Date: October 09, 2007

To: T10 Committee (SCSI)

Subject: SPC-4: UML model for CbCS

Figure 1 — CbCS class diagram

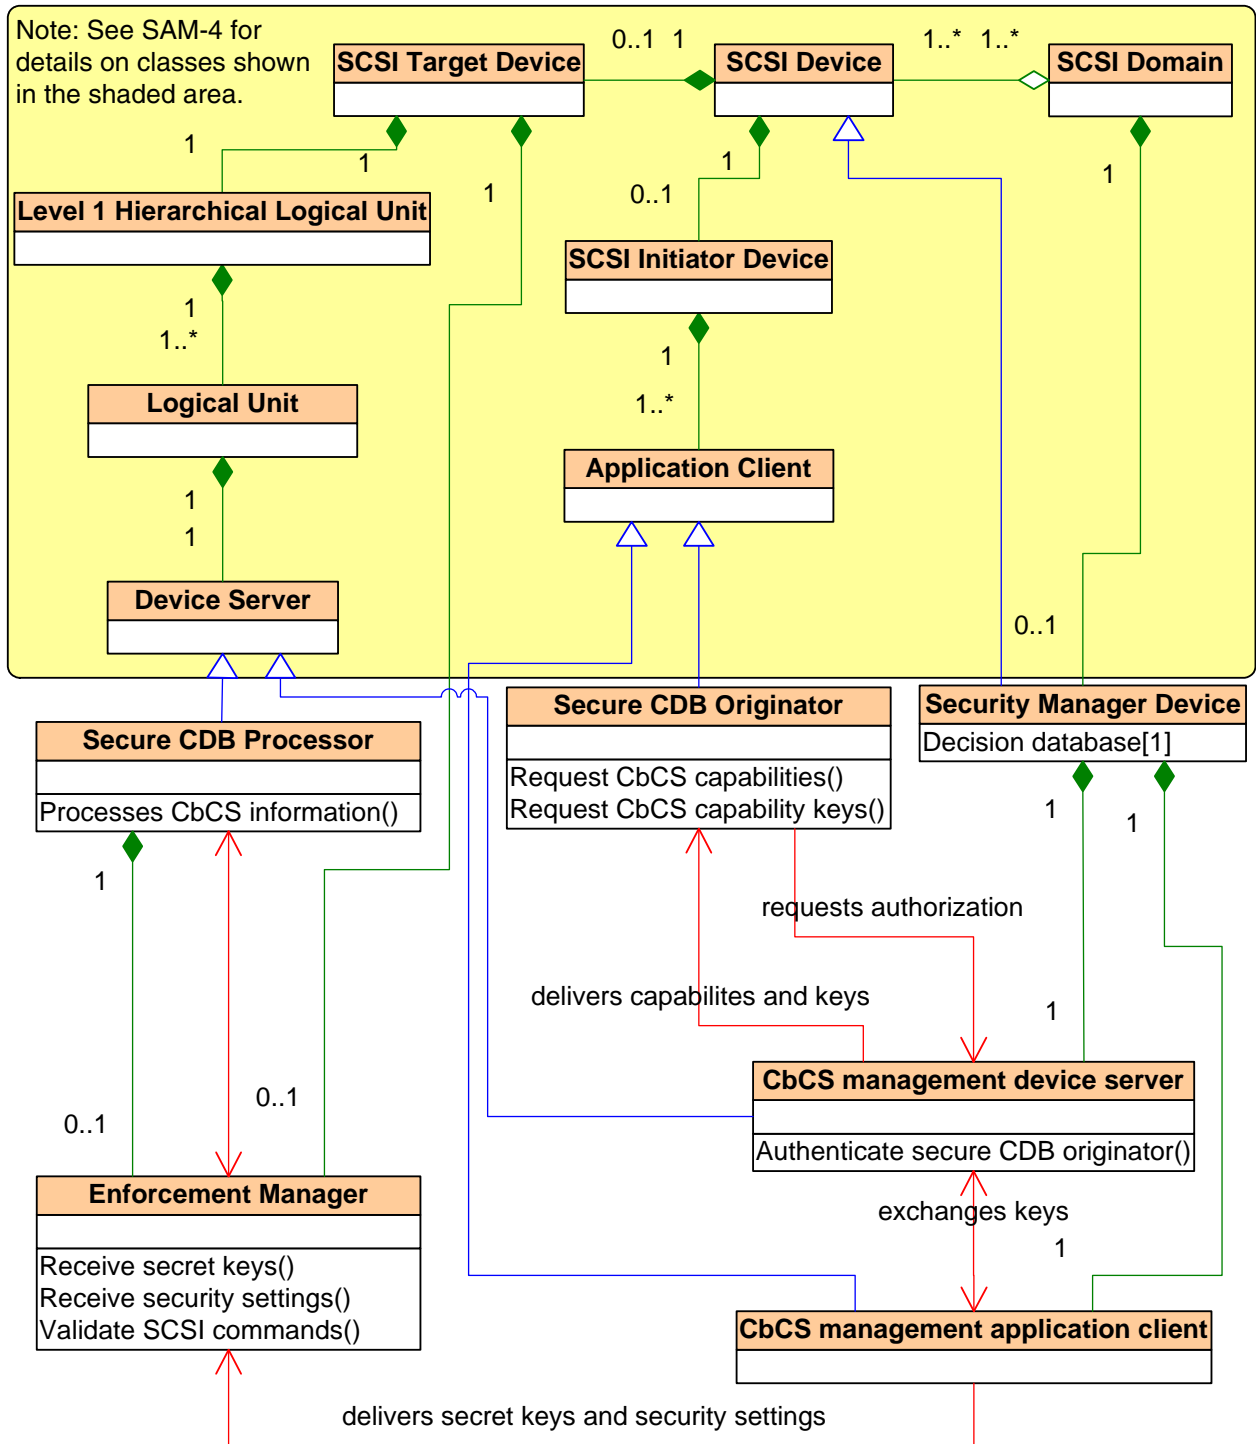
The CbCS class (see figure 1) is composed of a:

- a) Security Manager Device class (see 5.13.5.3) that contains:
  - A) A CbCS Management Device Server class (see 5.13.5.4); and
  - B) A CbCS Management Application Client class (see 5.13.5.5).
- b) SCSI Initiator Device class (see SAM-4) that contains:
  - A) A Secure CDB Originator class (see 5.13.5.6);
 and
- c) SCSI Target Device class (see SAM-4) that contains:
  - A) A Secure CDB Processor class (see 5.13.5.7); and
  - B) An Enforcement Manager class (see 5.13.5.8);

Figure 1 shows the flow of transactions between the components of a CbCS capable SCSI domain.

Each instance of a CbCS class shall contain:

- a) one security manager device that shall contain:
  - A) one CbCS management device server; and
  - B) one CbCS management application.
- b) one or more SCSI initiator devices that shall contain:
  - A) one or more secure CDB originators;

- a) one or more SCSI target devices that shall contain:
  - A) one secure CDB processor per logical unit; and
    - a) one enforcement manager per secure CDB processor;
    - b) one enforcement manager per SCSI target device; or
    - c) both;
